ADDENDUM TO BID DOCUMENTS

Pleasanton Unified School District	ADDENDUM 02
	Project: Staff Parking / Ballfield Fence at Foothill High School Project (2021-22.13)
	Date: April 20, 2022

1 PARTIAL CONSTRUCTION SITE PLAN
SCALE : 1" = 20'-0"

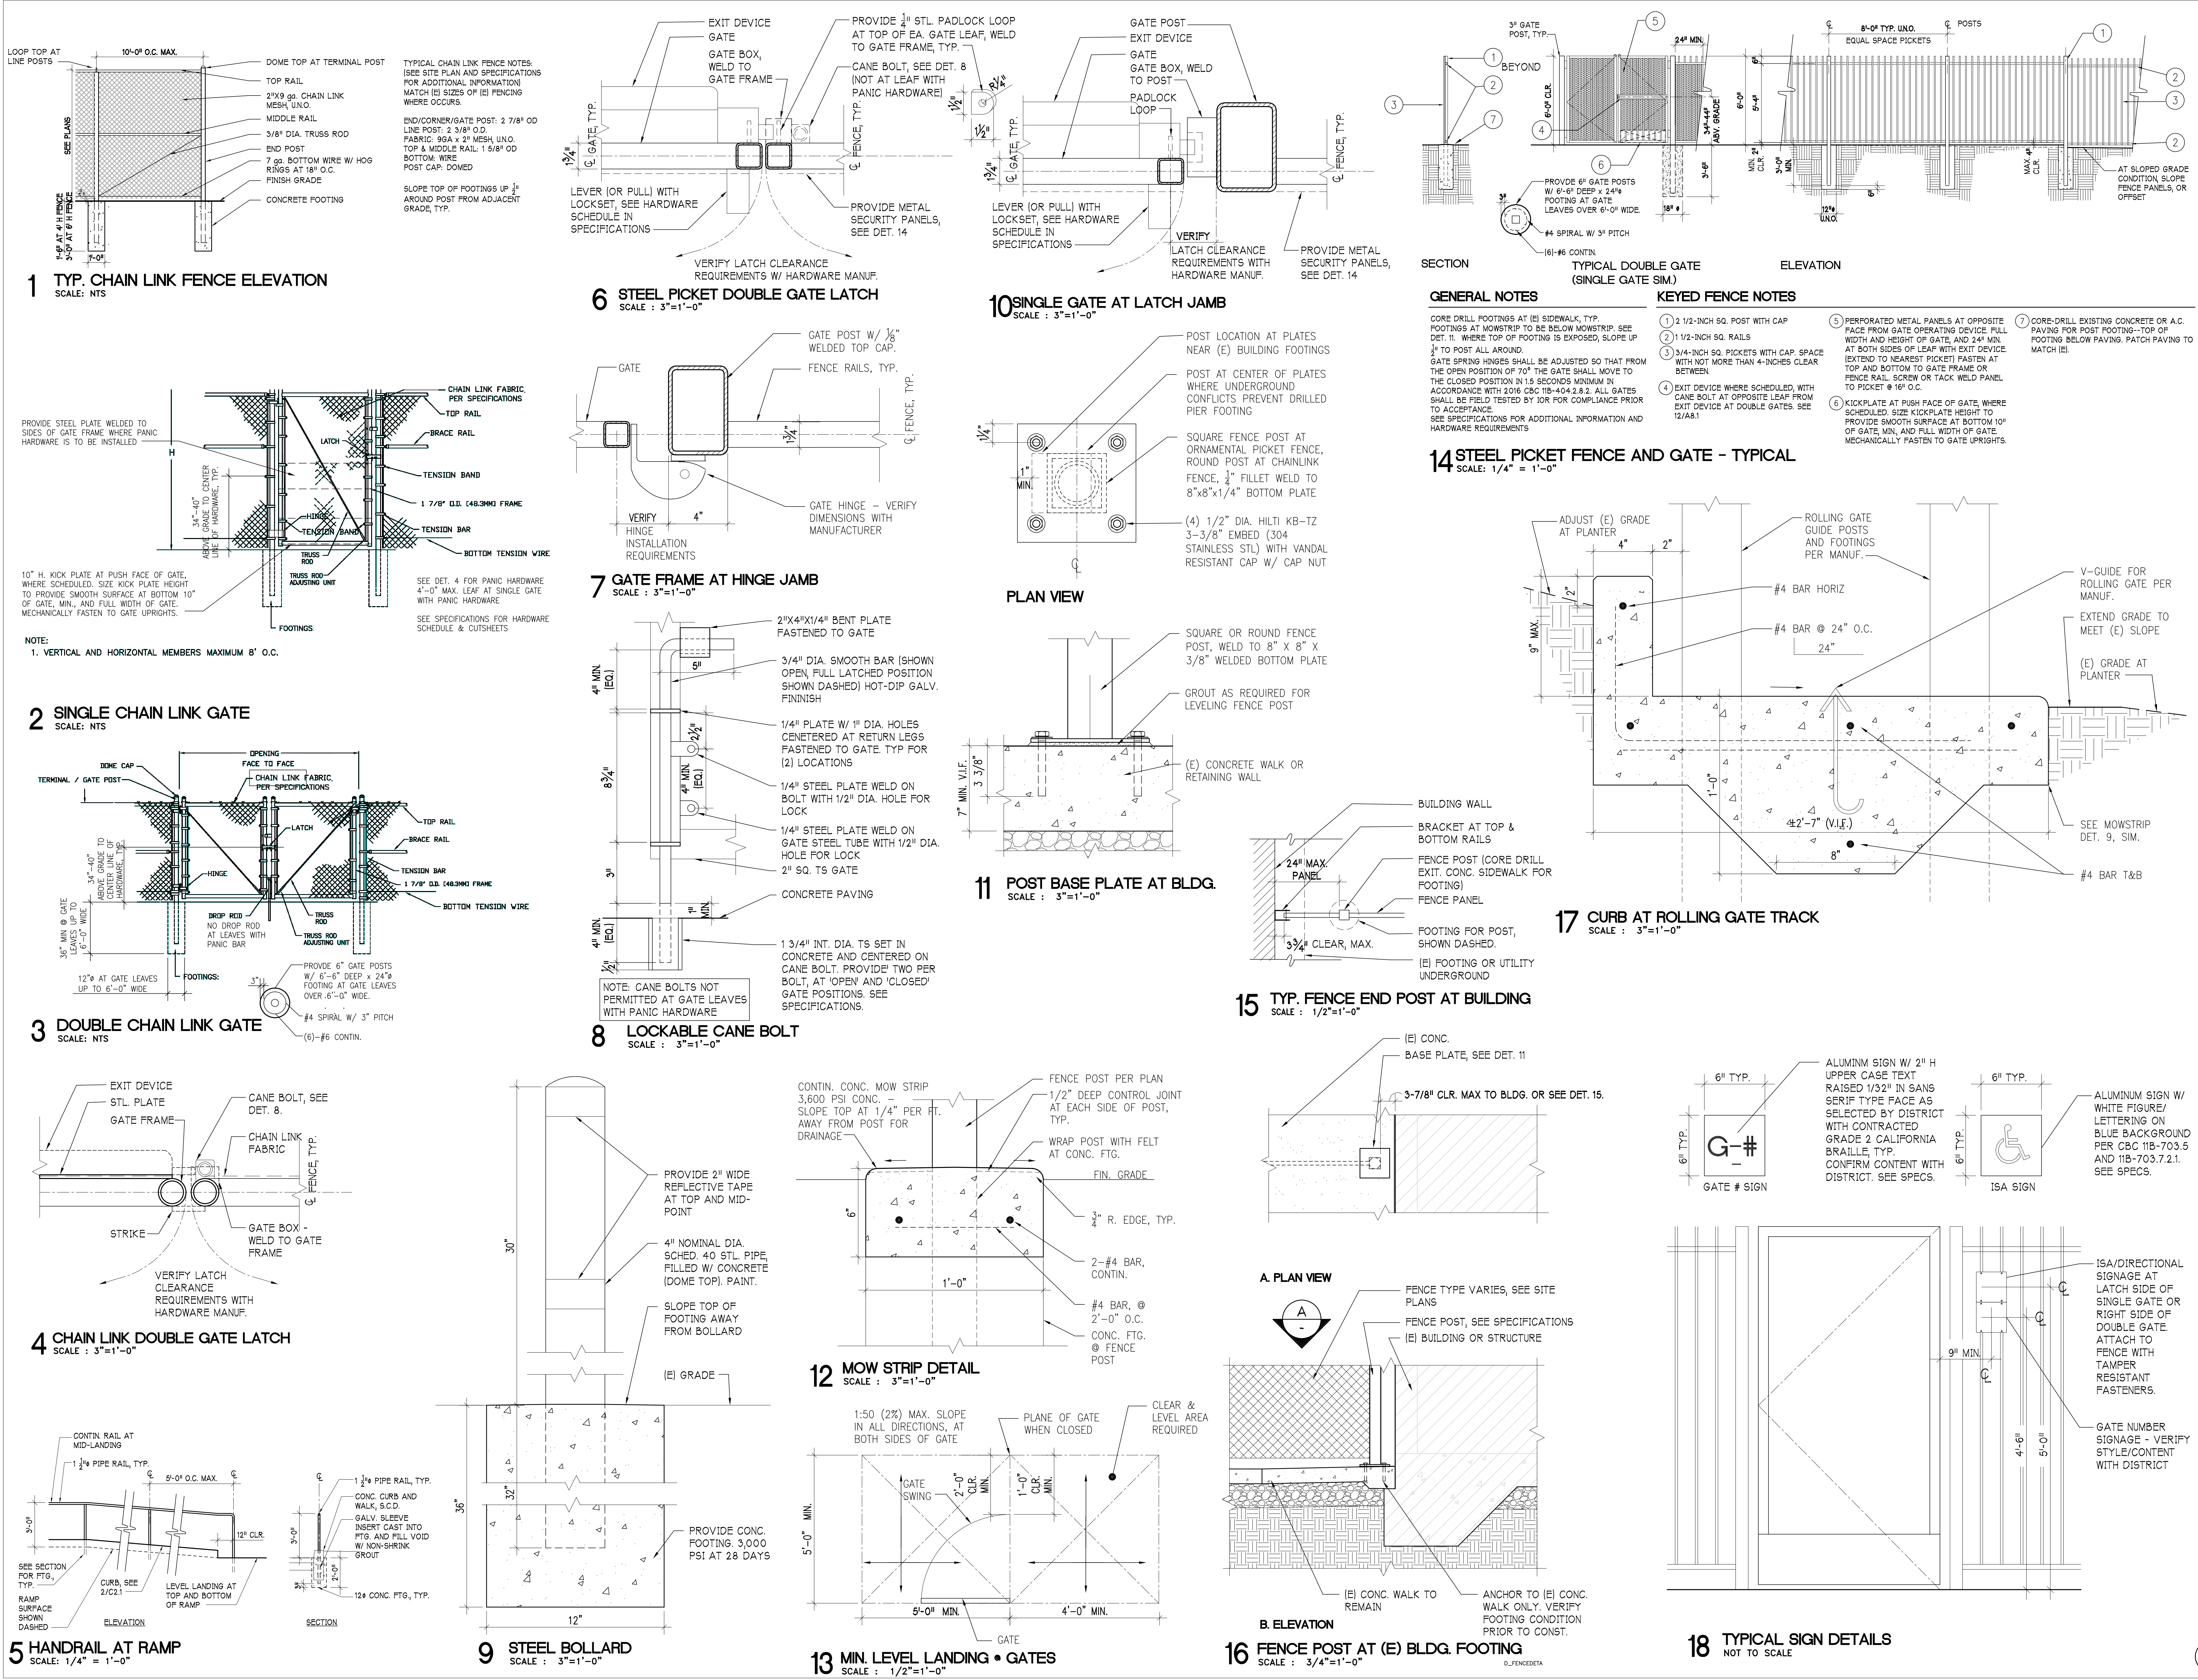
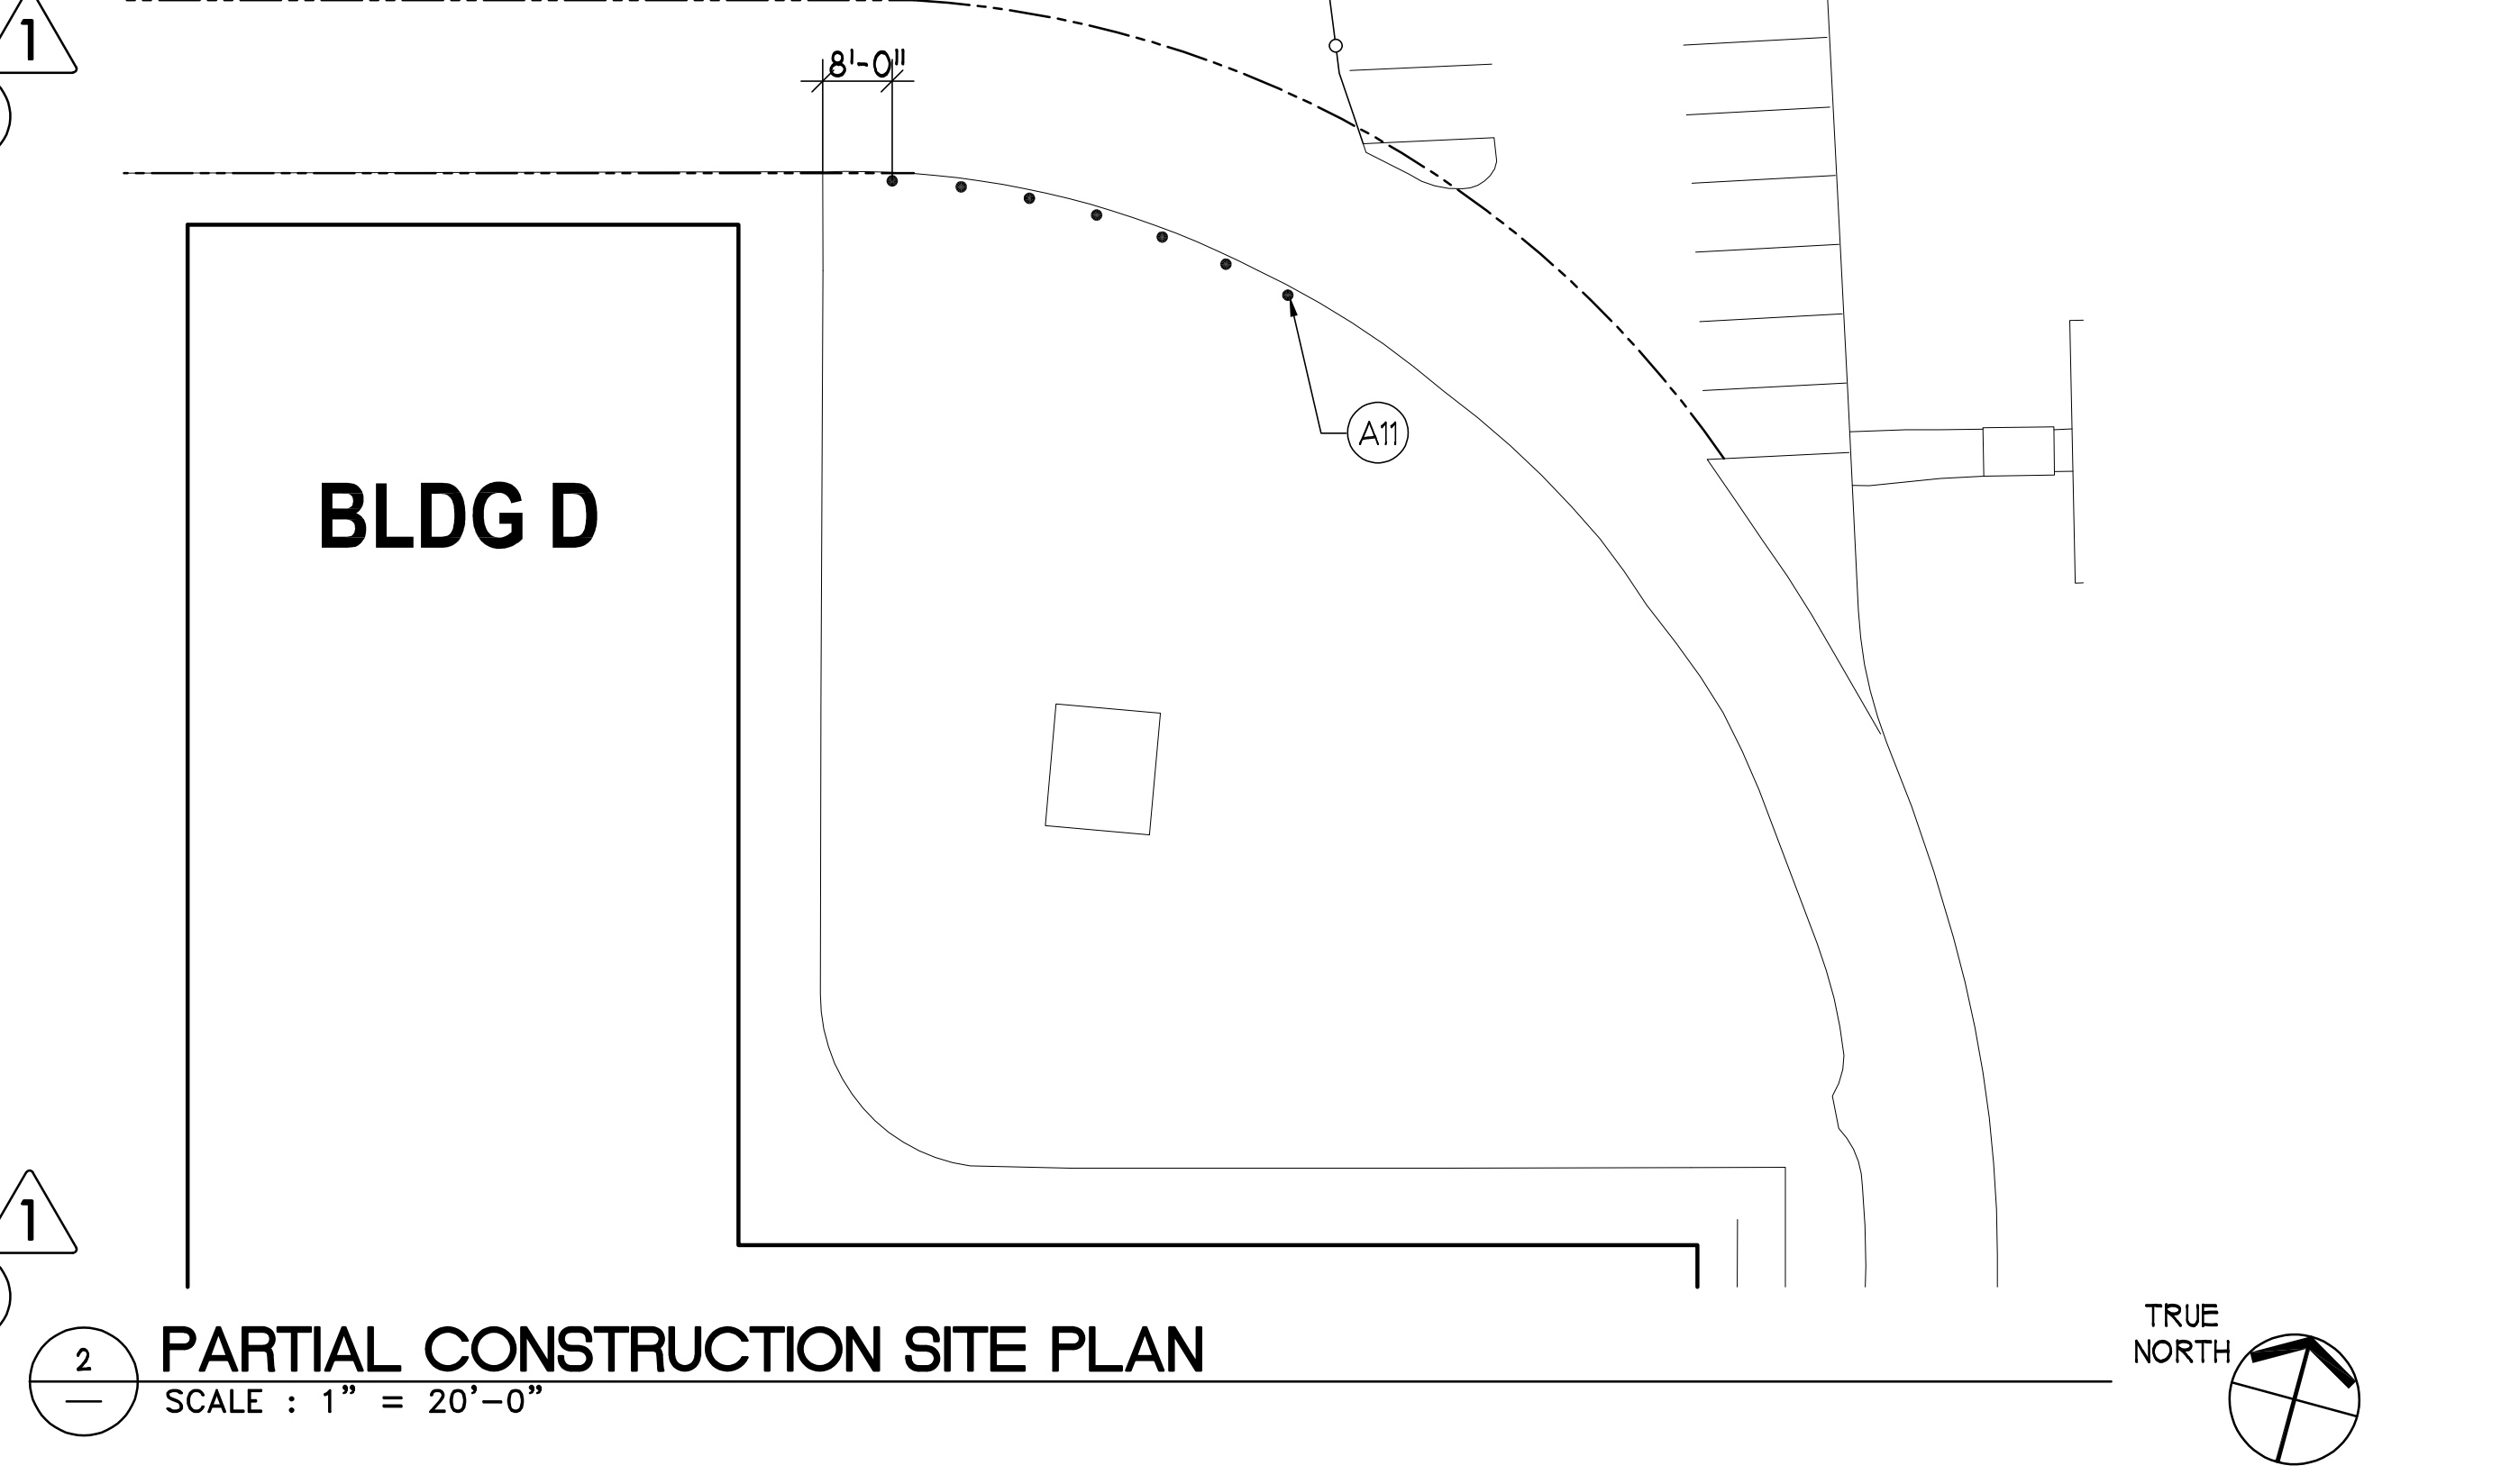
2. **Subject:** Revision to Access and Construction Notes and Gate and Hardware Schedule

Reference: A1.3

Description of Change: Replace sheet A1.3 in its entirety

(A23) REINSTALL (E) BIKE RACKS (TYP. OF 4). PROVIDE ANCHOR BOLT AT EACH FASTENING LOCATION, EMBED MIN 6" INTO PAVING, EPOXY SET.
